White Pond Advisory Committee  
Bruce Freeman Rail Trail  
Phase 2D update  
(last ½ mile in Concord)  
January 26, 2022

WPAC meeting - Bruce Freeman Rail Trail – phase 2D

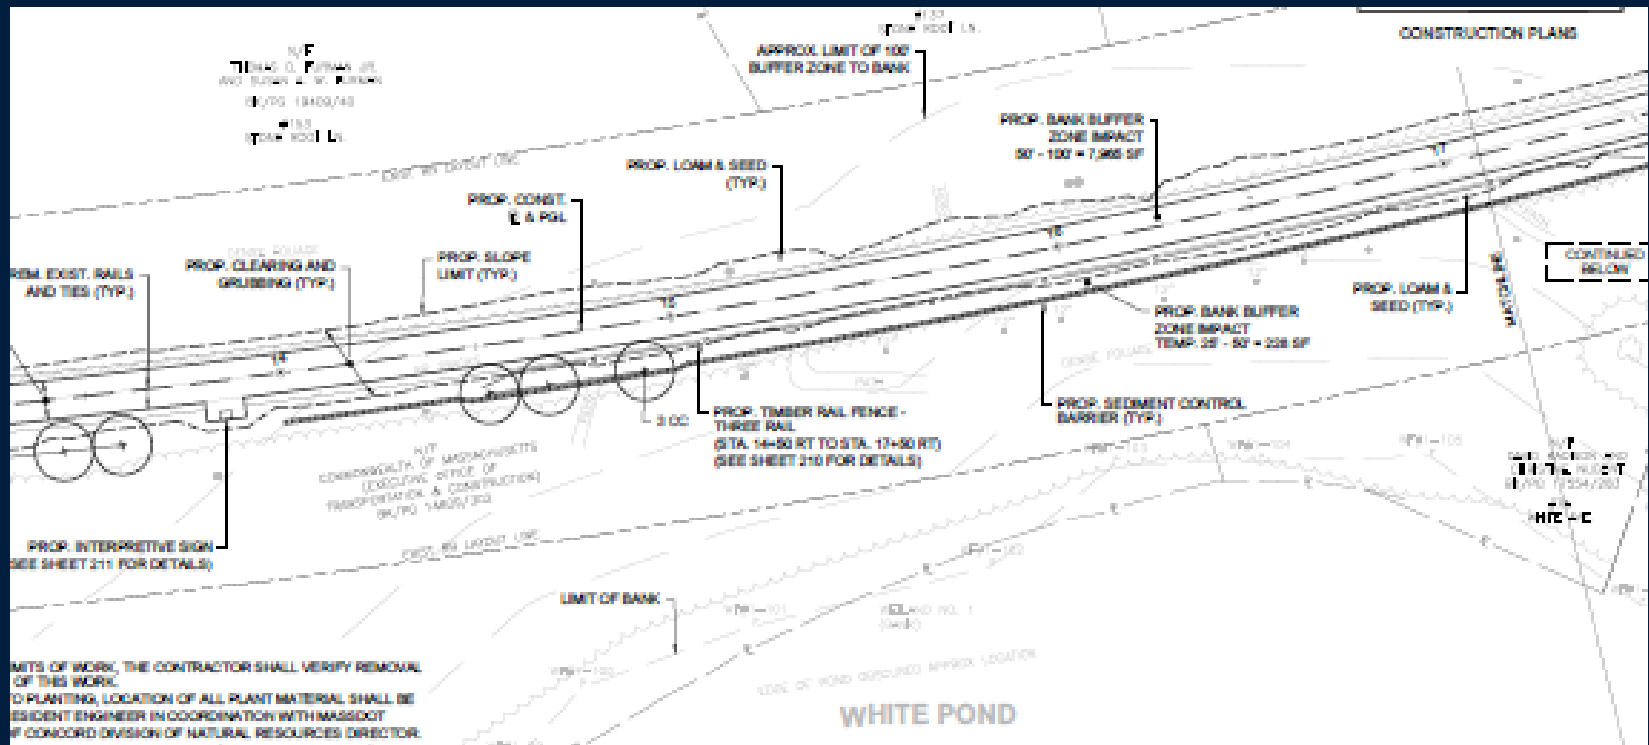
MassDOT request that you work with the P.M. and MassDOT staff to re-submit (informally) the plans showing the fencing while adhering to the understanding that the fencing in question can only be installed for the safety of the trail users. The fence cannot be installed as a participating item to “define the trail”, the pavement and the tree line will already do that. The concern of the abutters is heard but as said before the fencing is to be installed for public use and safety of the trail user and not for private individuals. An example of the correct use of fencing is as noted in your letter to protect the users from steep drop offs or danger of traveling into water bodies.

In addition, the 6’ ornamental fence and gates are not permitted. A vinyl coated chain link fence can be considered along the layout line near White Pond however no gates can be proposed and leaving a gap in the fence at the beach access trail would defeat the purpose and declared need of the fence in the first place. I also understand that installing this fence along the layout line is not feasible due to the topography of the location and the need to remove trees for installation.
